REVISED ATTACHMENTS - PRE-APPLICATION CONFERENCE

Advanced Builders Four-Plexes (2024-009-PAC)

Meeting conducted on Wednesday, April 10, 2024, – 2 p.m.

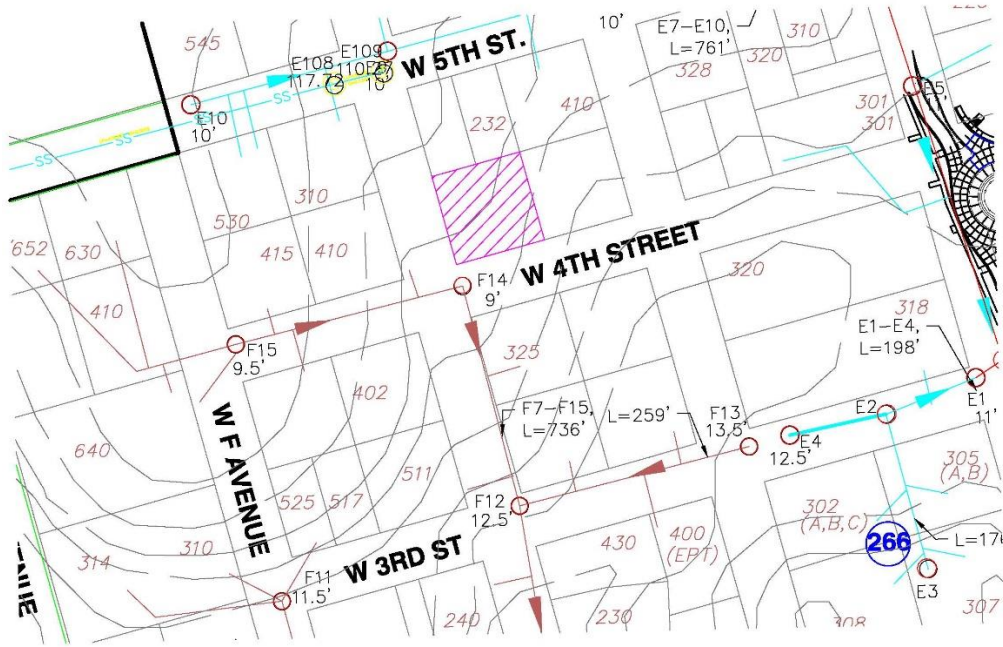
In order to grade this new half street, the elevation of the parking lot will need to be raised to allow the street frontage to meet a minimum longitudinal street grade of 15% and 2% cross slope. Because the access to the site is more than 290 LF from 3rd Street, at a minimum a hammerhead turn around will need to be installed on 4th Street to allow a fire truck to turnround. See attached schematic plan with contours.

Half street improvements will need to be constructed on the east side of W. E Avenue to local street standard, adjacent to Unit A. North of Unit A, the width of W. E. Avenue is only 17-feet wide. An asphalt taper will be needed along the north edge of the half street improvements, to taper to the existing street. W. E Avenue may need to be widened south of 5th to the site, to meet a minimum 20-foot wide road width. See the schematic drawing.

Sewer Connection Map

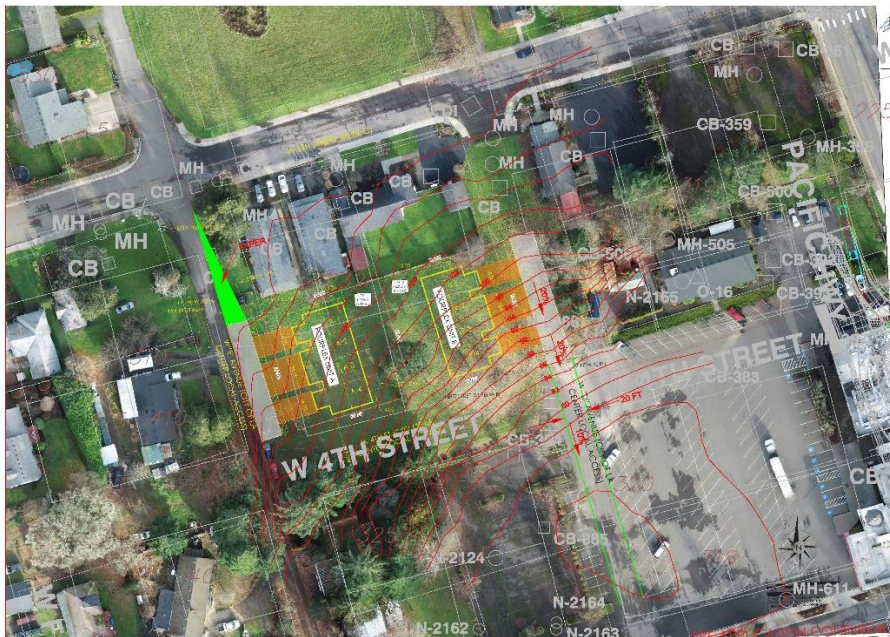
The applicant can connect to the sanitary sewer lateral from each unit to the existing manhole at the intersection of W. E Street and 4th Street via grinder pumps and force main. One grinder pump will be needed for each unit connecting to a force main in the east edge of W. E Street right of way. The city does not maintain grinder pumps or the force main in public right of way that serves a lot. This force main is considered a sewer lateral, and the installation and maintenance of this pipe shall be borne by the property owner.

The second option to connect to the public gravity sewer is in 3rd Street just south of W. D Avenue. A gravity public sewer main would need to be extended from the site along W. D Avenue to connect the existing manhole in 3rd Street to connect by gravity. See the attached schematic sewer map.

Figure 1: Mapped Landslide Hazard Area

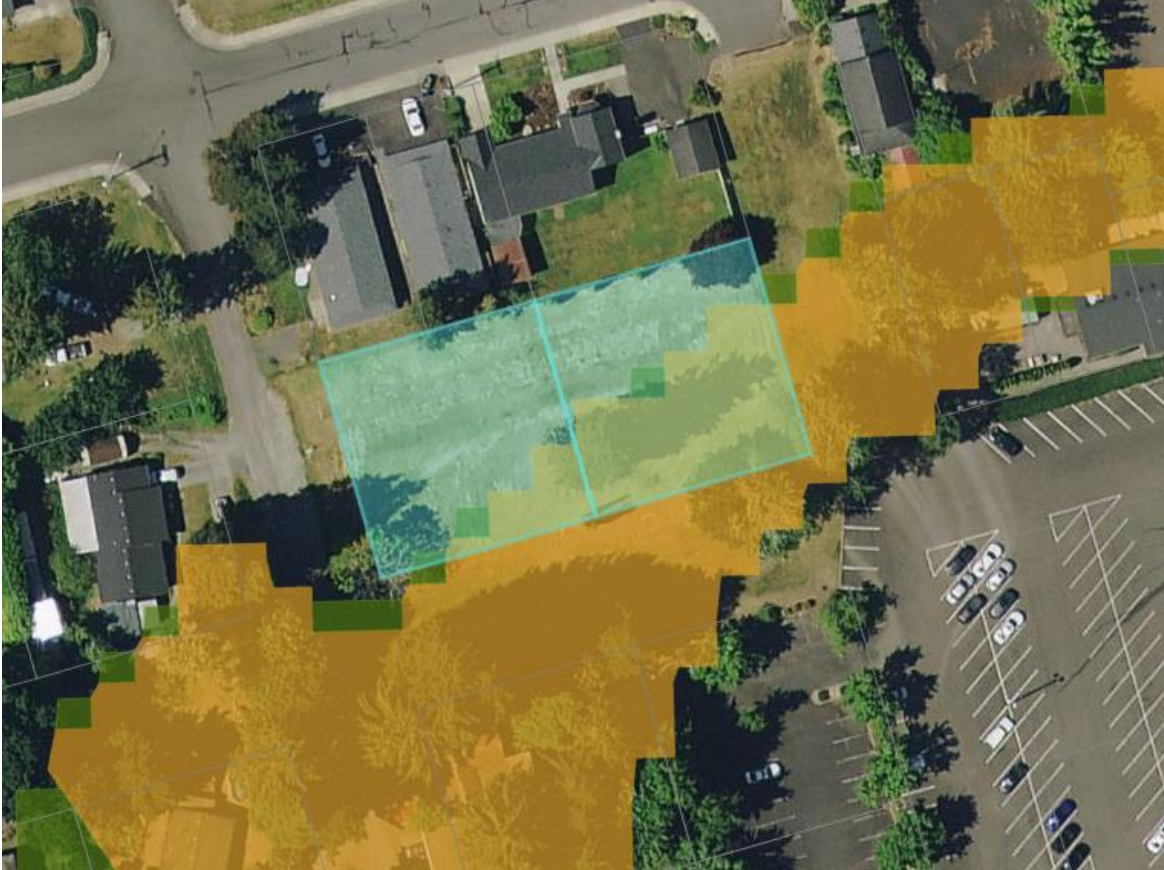
The southern portion of the site is mapped as a landslide hazard area (Figure 1) and is therefore must apply for a critical areas permit and file a critical area report (18.300.040) in the form of a geotechnical report. Alternatively, if the applicant submits a stamped letter from a geologist or geotechnical engineer stating that the landslide hazard is not present, then a critical areas permit is not required. Please refer to the definition of “landslide hazard area” in LCMC 18.300.030 and note that a geotechnical report may, nevertheless, still be required by the building official.

Figure 3: Mapped 10-year Time of Travel Zone (in teal)

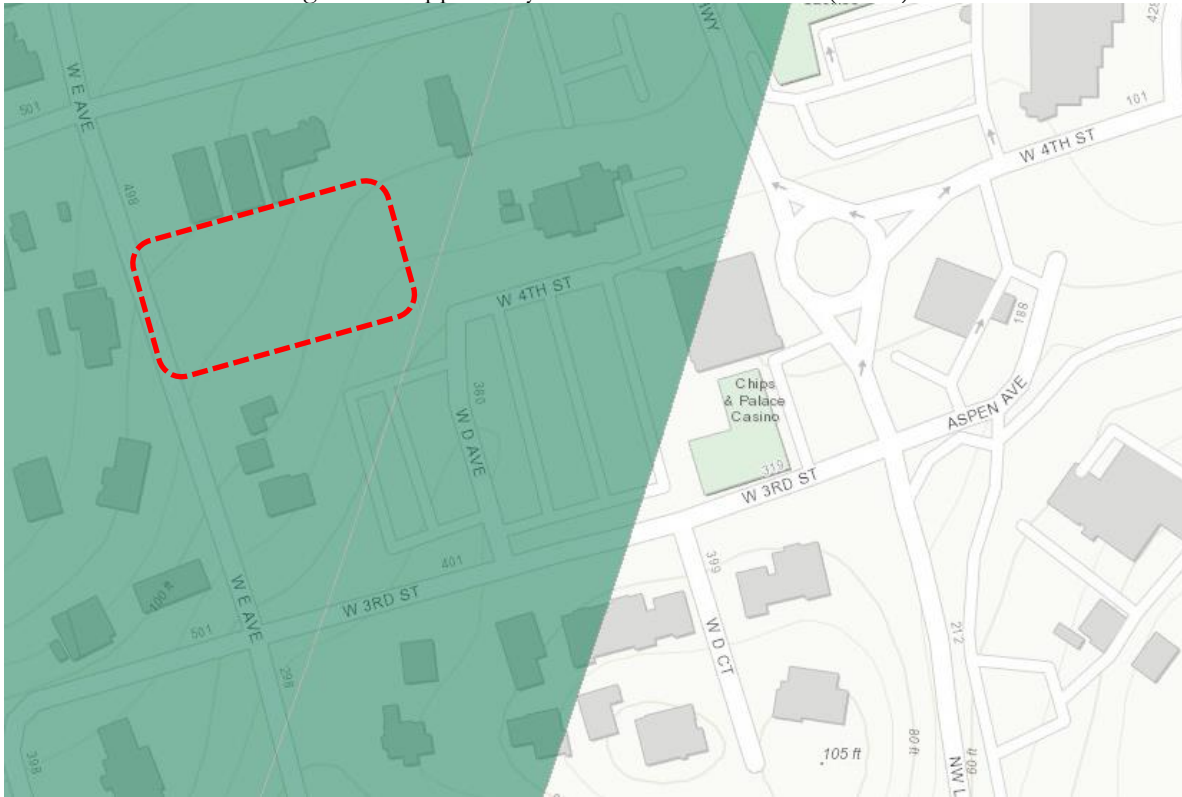
The project is mapped by the Washington State Department of Health within a 10-year time of travel zone for a Group A well (see Figure 3), which are regulated as Type I CARAs. However, as this project is a residential land use, these are typically exempt from CARA regulation in most jurisdictions. Staff will prepare a code interpretation letter that exempts residential uses from the requirement to provide a hydrogeological assessment since residential uses do not impact CARAs. The interpretation will omit the requirement for this project to apply for a critical areas permit for the CARA.
